Docket No. : 030-01221  
License No.: 04-01935-03  
Control No.: 70804

SUBJ: Amendment to NRC Radioactive Materials License 04-01935-03; Xenon-133 Use

SUBJECT: PRE-LICENSING VISIT HELD ON MARCH 2, 1989

Calculation of Xenon-133 Concentrations to  
Unrestricted Areas - V.A. Fresno.

Figure 1 V.A. Fresno Imaging Area

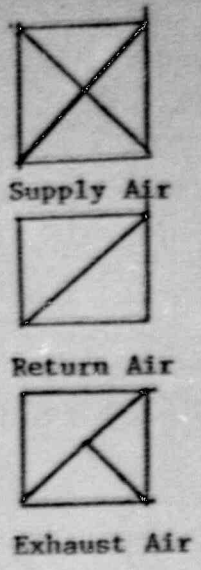
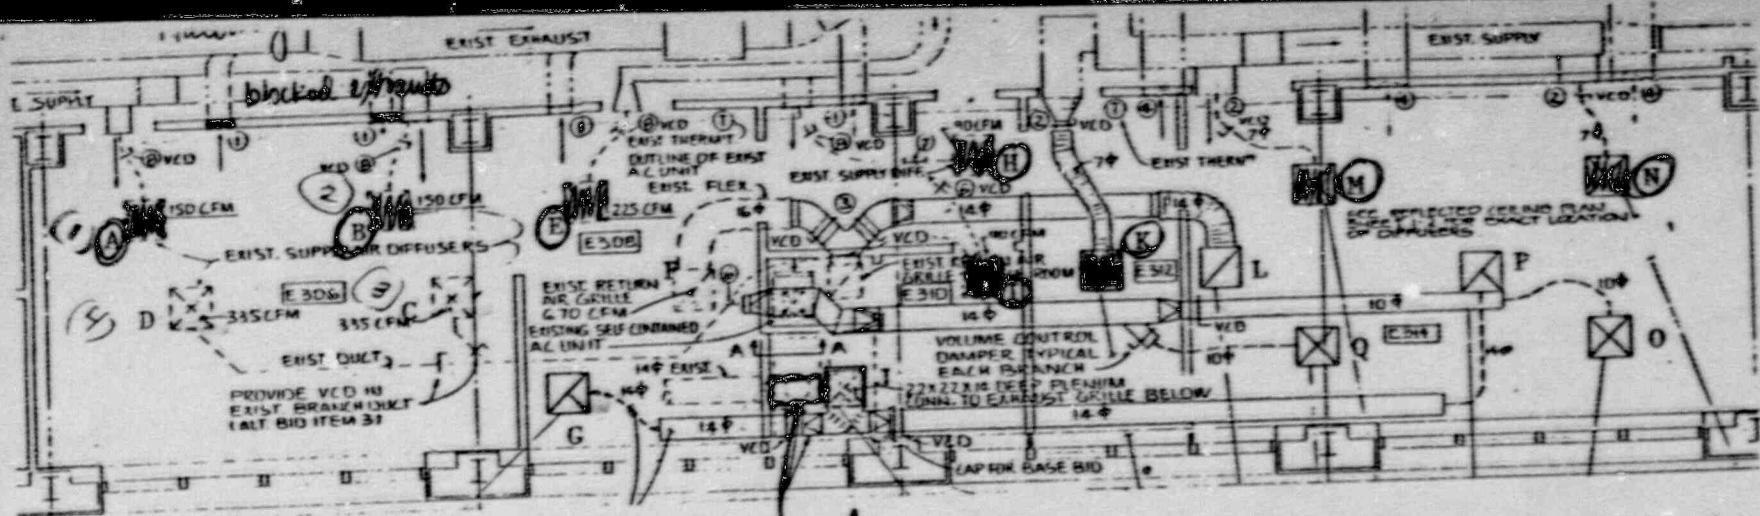
We toured the nuclear medicine imaging area. Several rooms are connected to make up the imaging area. Inner doors are open, but doorways to the hall are normally closed and locked. Exhaust vents which used to connect to the hospital system have been closed off completely. There is an air conditioning system which recirculates the air within the imaging area. The system is dedicated to that area - air is not distributed to other rooms. Vents used with the air conditioning system are noted as D, C, G, F, L, Q, P, and O on the attached blueprint drawing (Figure 1).

Vents A, B, E, H, I, K, M, and N are all supply vents. All vents have a 1.4 square foot cross-sectional area. Flow rates as measured by the RSO are given below:

Vent	Linear flow rate	CFM
A	80 lfpm	112
B	80	112
E	90	126
H	80	112
I	blocked off	--
K	70	98
M	70	98
N	80	98
Total Supply:		756 cfm

There is a fume hood in the hot laboratory which has a linear flow rate of 140 lfpm. The sash opening has an area of 9.7 square feet, for a 1358 cubic foot per minute air flow. The fume hood vents to the roof of the facility. Air intakes are located on the sides of the facility, not on the roof. The normal wind direction (NW) would blow the xenon 133 effluent away from the air intakes.

With the fume hood running, the imaging area is under negative pressure with a net exhaust of 602 cubic feet per minute.

Calculations performed onsite are attached as Appendix A to this memo. They indicated that the licensee needs a charcoal trap with the xenon system in order to meet the limits for unrestricted areas which are stated in 10 CFR Part 20.

The unrestricted area limit for xenon-133 is  $3 \times 10^{-7} \mu\text{Ci}/\text{ml}$ . The VA Fresno is slightly above the limit. The fume-hood on-time will be revised to correct this situation.

The licensee agreed to recalculate xenon concentrations and take another look at the length of time needed to run the fume hood during and after each study. They will also calculate the spilled gas clearance time and request that unnecessary documents be deleted from License Condition 17.
